(4)
D350-748-243TRN
Job Sheet 181743

Part Name: Crosstube Installation, High Aft

DRAWING NO. D350-748-243
REV. A
SHEET 1 OF 4

DRAWING NO. D350-748-243	TITLE CROSSTUBE	REV. A	DART AEROSPACE LTD ENGINEERING ORDER		D.E.O. NO. D350-748-243-A-1	SHEET NO. SHEET 1 OF 1	SCALE NTS
DRAWN <i>q</i>	CHECKED <i>ASS</i>	MFG. APPR. <i>[Signature]</i>	APPROVED <i>[Signature]</i>		DE APPR. <i>[Signature]</i>		
DATE 15.11.18	DATE 15.11.18	DATE 16.02.19	DATE FEB 19 2016		DATE 2016.02.19

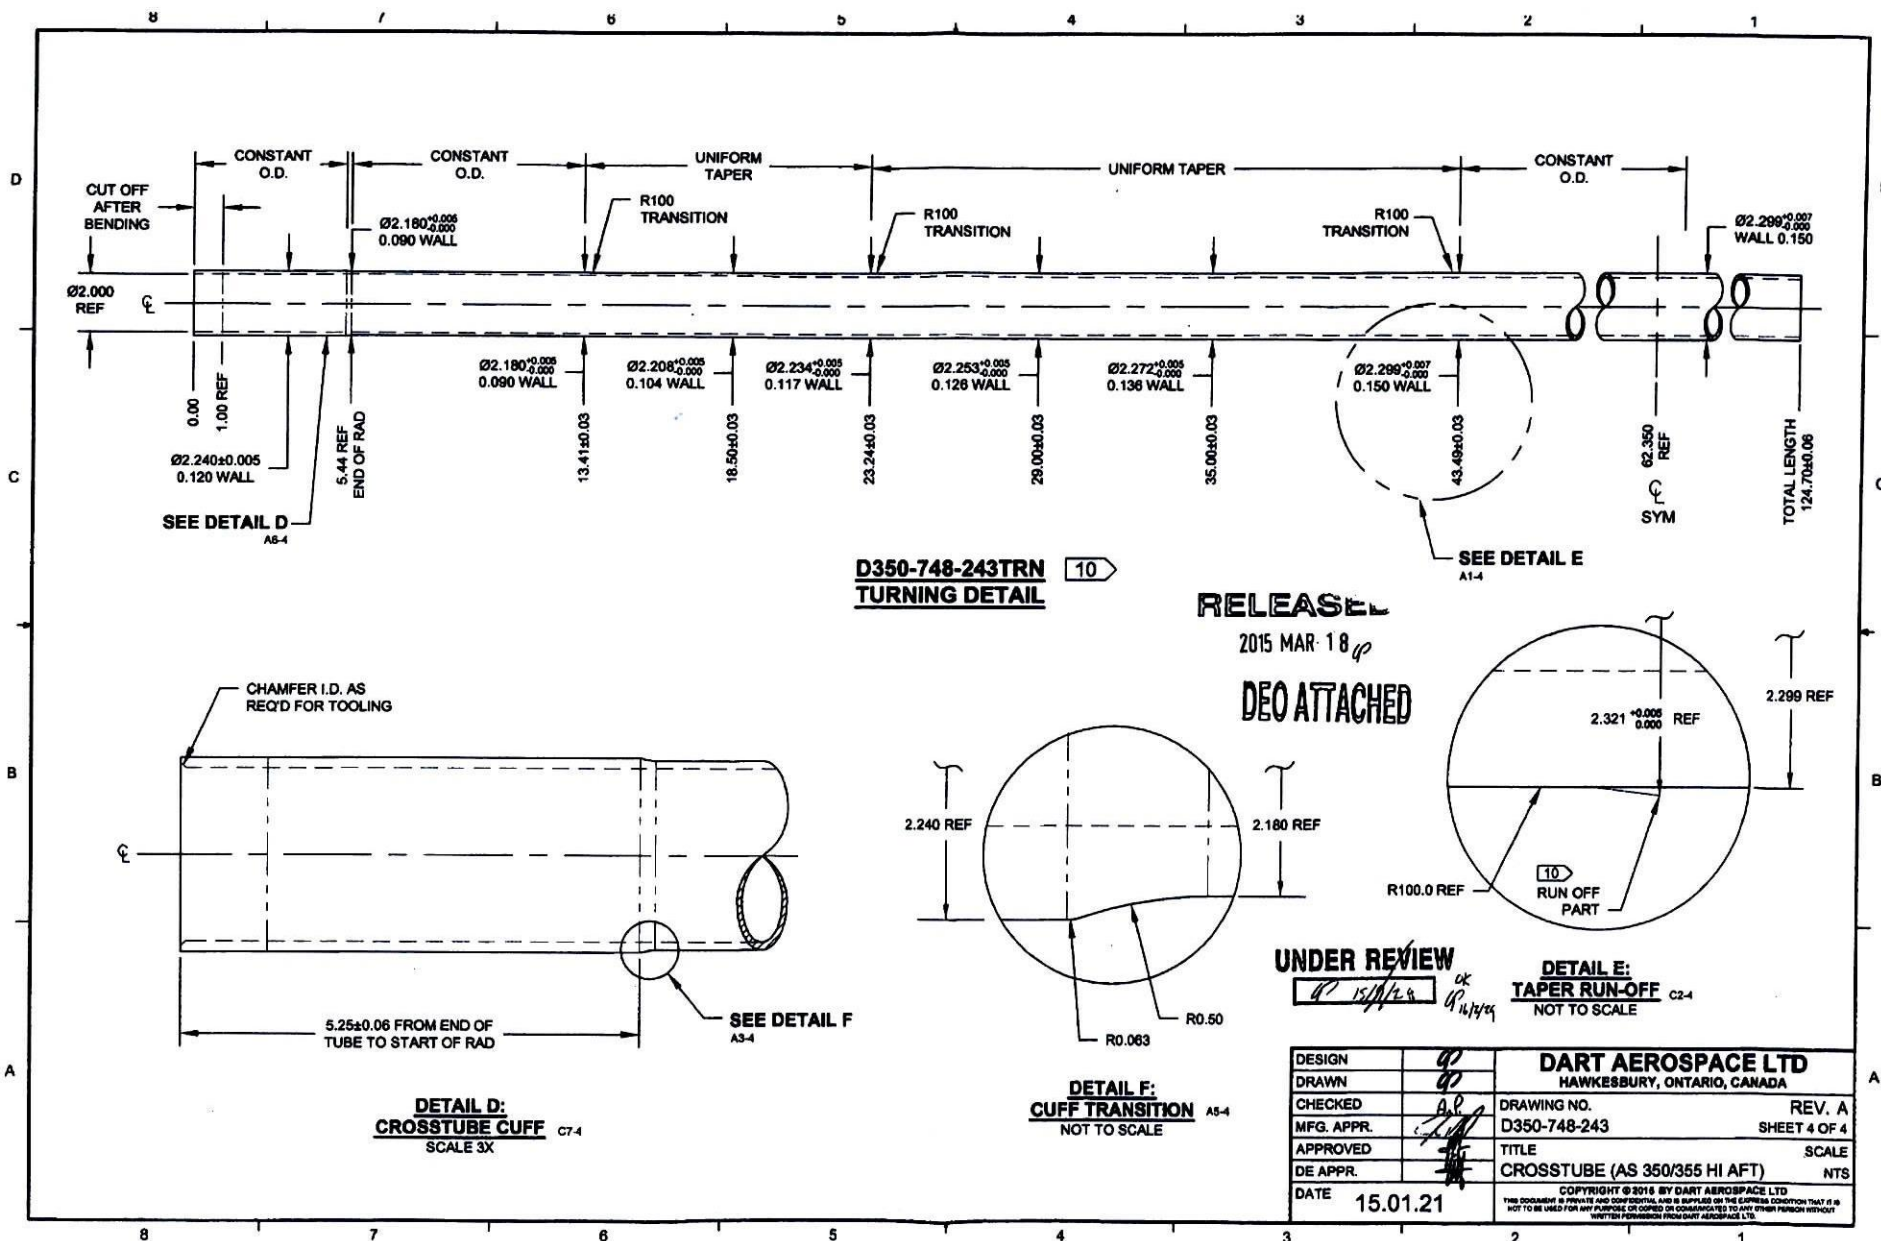
AMEND NOTE 2 (SHEET 1) AS FOLLOWS:

- 2) FINISH: PREPARE SURFACE PER DART QSI 005 4.1.4
 PRIME INSIDE AND OUTSIDE PER DART QSI 005 4.2
 PAINT OUTSIDE PER DART QSI 005 4.2
 OR
 POWDER COAT WHITE (4.3.5.2) PER DART QSI 005 4.3
